Project Name
Project Number
Project Address
LAHC Villawood
12620
Kamira Avenue,
Villawood, NSW 2163

Reference is made to the Planning Panel's recommendation that the applicant provide to the Council its commentary on the Council's Report to the Panel received on 21 December 2022. It is noted that the determination meeting has shifted from early February to late February and this submission aligns with the shift in timing.

TO: Sydney Western City Planning Panel

Reference is made to the abovementioned development application and the Final Briefing Meeting to be held via Microsoft Teams on Monday 27 February 2023. Council received additional information from the Applicant on Monday 13 February 2023 including revised plans, proposed amendments to Council's draft conditions and responses to Council's reasons for refusal. Council has reviewed the additional information submitted and Council's responses are provided in the body of this Supplementary report and the attached documents (Attachment B – Responses to the proposed changes to Conditions of Consent).

Figure 2: Proposed Height Controls by Applicant – completely aligned with Councils proposed DCP changes

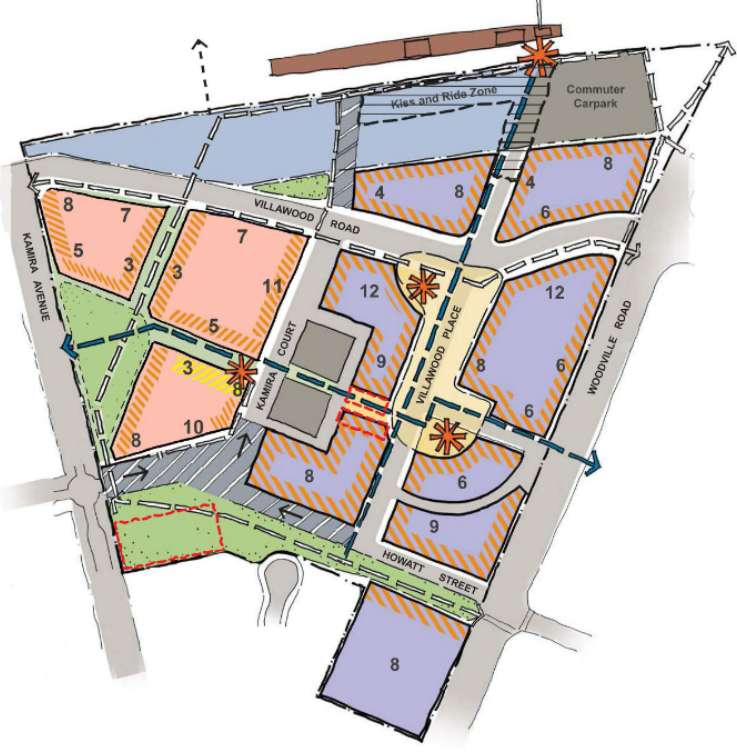
Item	Council’s Position as per report 16 December 2022	Applicant Response
1	<p>Inconsistent with Draft Villawood DCP 2020</p> <p>Pursuant to the provisions of Section 4.15(1)(a)(iii) of the Environmental Planning and Assessment Act 1979, it is considered that the proposed development does not comply with the Draft Villawood DCP 2020. The proposed development does not comply with Clause 4.2.2 and the maximum building heights. The number of stories exceeds the maximum permitted storeys as identified within the DCP.</p>	<p>Fairfield Council is changing the DCP to be consistent with the proposal.</p> <p>Villawood Town Centre DCP will be reported to Council’s Outcomes Committee on 18 February 2023.</p> <p>The Applicant has worked collaboratively with Council strategic staff that will see the Villawood DCP amended to be consistent with that proposed in the Development Application, with respect to massing and height.</p> <p>The process of review undertaken with the Council’s strategic town planners and their advisers (Gyde) supported a more thoughtful approach to the site and this has subsequently aligned the proposed masterplan with that of the DCP.</p> <p>Further, the liveable areas are compliant with the LEP height limits as stated in the Fairfield Local Environmental Plan 2013.</p> <p>Below are the figures from the newly created Villawood Town Centre DCP showing permitted compliance from the proposed Stage 1 DA massing and floor levels.</p>  <p>Figure 1: The Council proposed Villawood Town Centre DCP Height Controls</p>
